TENNESSEE VALLEY AUTHORITY

In the Matter of the Application of) Docket Nos. 50-390
Tennessee Valley Authority) 50-391

WATTS BAR NUCLEAR PLANT UNITS 1 AND 2
NRC POWER SYSTEMS BRANCH REVIEW ITEMS
NRC SPECIFIED STATUS AS OF NOVEMBER 1, 1983

ENCLOSURE 2
WATTS BAR NUCLEAR PLANT UNITS 1 AND 2

Figure 8.1-5

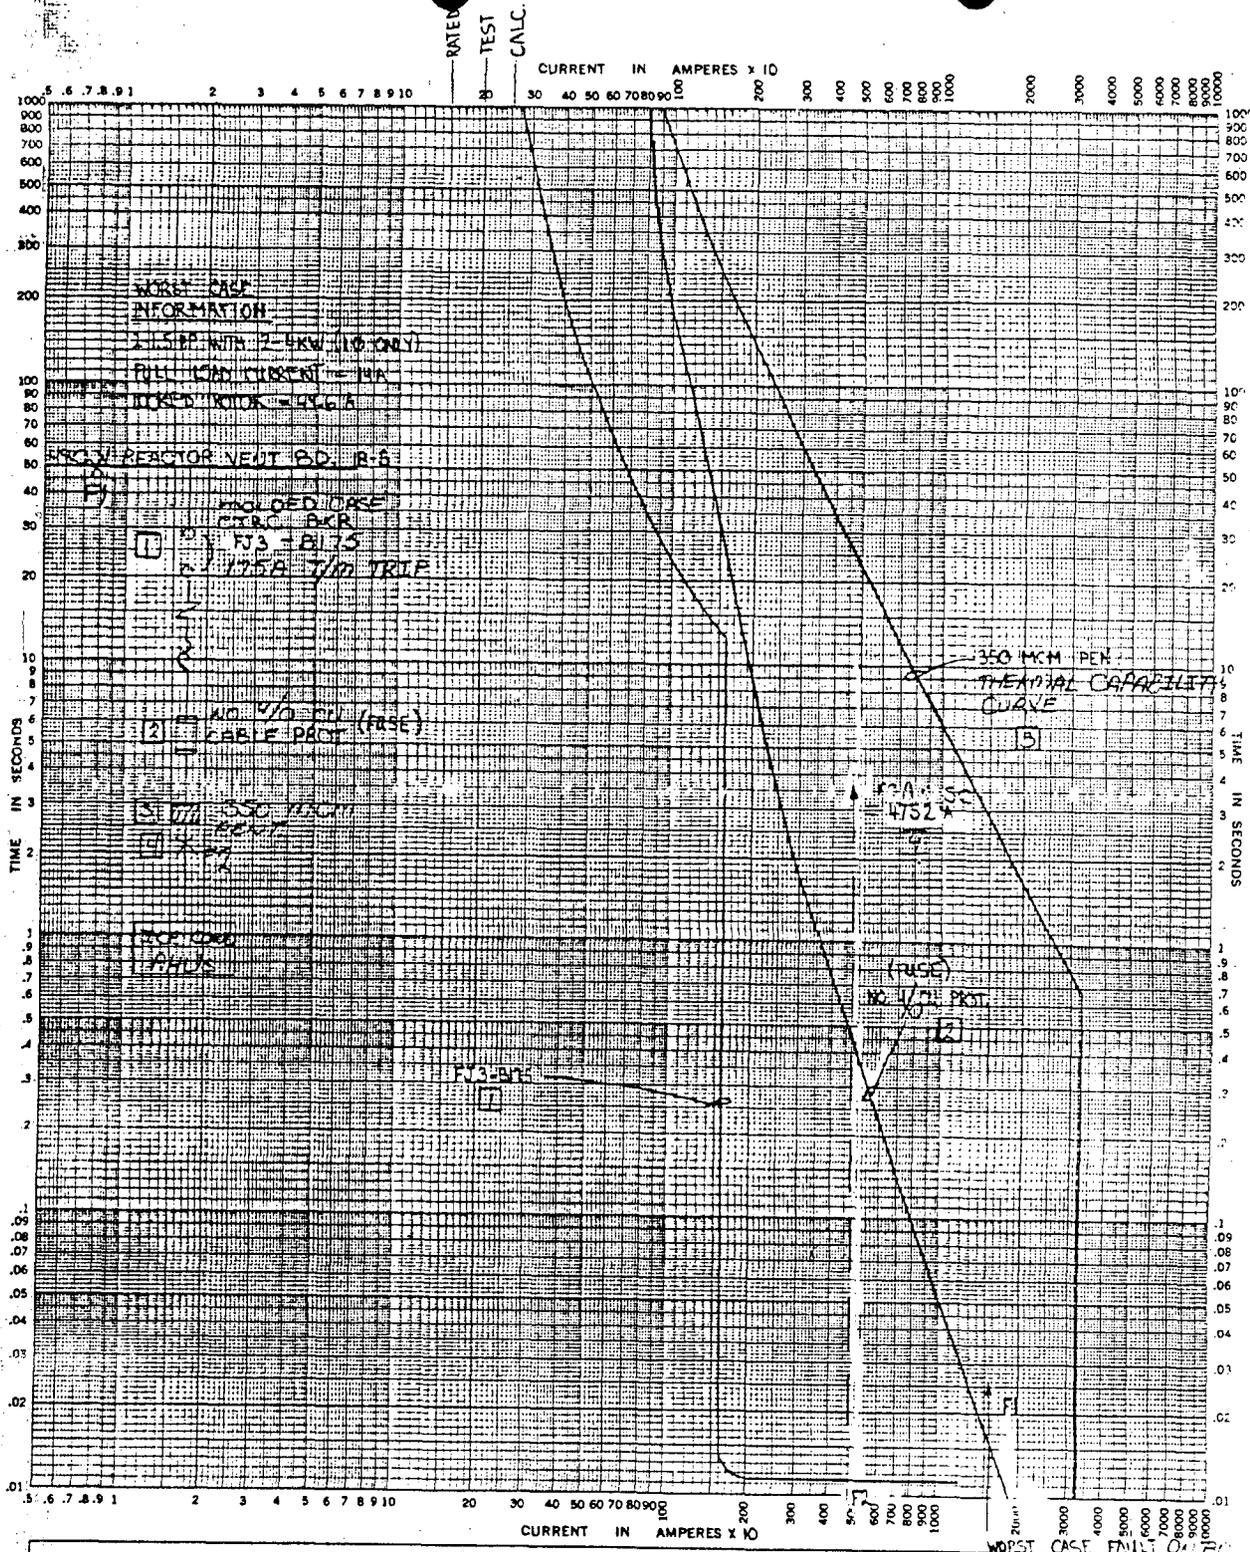
- a. 480-volt circuits shown on figures 8.1-5 through 8.1-7 of the FSAR use cable protectors. It appears, for example, that 4/0 copper cable is used as the protective device or fuse. Clarification of this item will be pursued with the applicant.

- b. The circuit shown on figure 8.1-5 of the FSAR appears to not have the required primary and backup protective devices, clarification of this item will be pursued with the applicant.

TVA provided additional clarification of protective device design and the NRC indicated that this matter was resolved.

As a result of discussions with the NRC on October 27, 1983 and November 1, 1983, TVA will revise page 8.1-8 and figures 8.1-5, -6, -7 of the FSAR to address this issue. Copies of the amended FSAR are attached.
